NRA presentation

- **C Authorization Process**
 - C-2-3 REIA – Potential exposure**

IAEA Regulatory Review Mission on ALPS Treated Water Handling
23 March 2022

FIG. 3. Components of an assessment for consideration of potential exposures. (The figure is not intended as a detailed step by step procedure and is presented to illustrate the elements of the assessment and facilitate its description.)

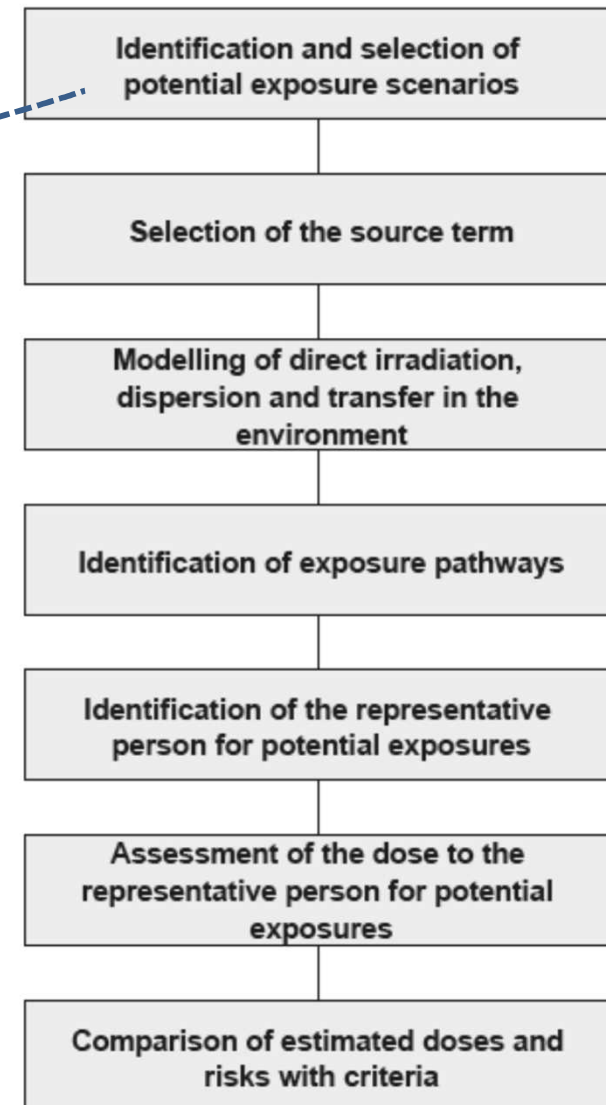
- Concept of the assessment which does not follow the flow shown in Fig. 3 of GSG-10
